### **Notice of deemed withdrawal**

**Application reference: PAN-018778**

**Facility: Afan Combined Heat and Power Facility, Afan Wastewater Treatment Works  
Harbour Road, Phoenix Walk, Port Talbot Steelworks, Port Talbot, SA13 1RA**

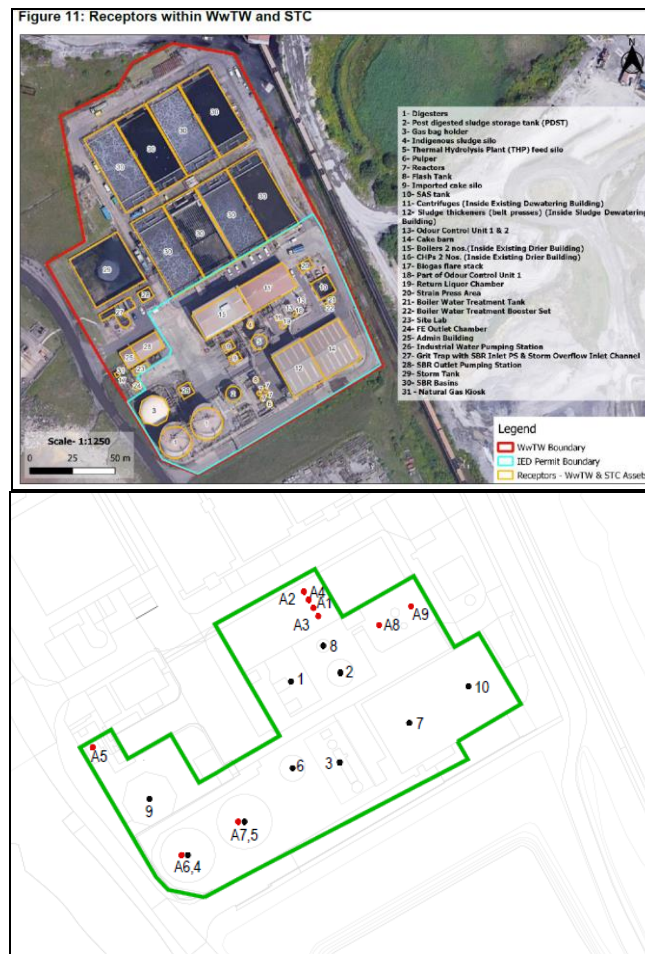
The Cake Barn has now been included within the revised assessment report submitted in October 2023 – with the applicant confirming that the barn falls within the confines of the STC permit boundary. However, the proposed permit boundary line now appears to cover a much larger footprint, which includes additional plant and infrastructure. The boundary line as shown within the revised CIRIA and AMP reports is illustrated below. The permit boundary line as confirmed within the applicants' response to the 1<sup>st</sup> Schedule 5 Notice and is subsequently illustrated underneath.

If the permit boundary line is to be extended to include a larger footprint of land, the applicant will need to re-submit updated reports including Site Condition Report (SCR); Main Supporting Document (MSD); Odour Management Plan (OMP); Site boundary plan; Site layout plan to reflect the change to their application.
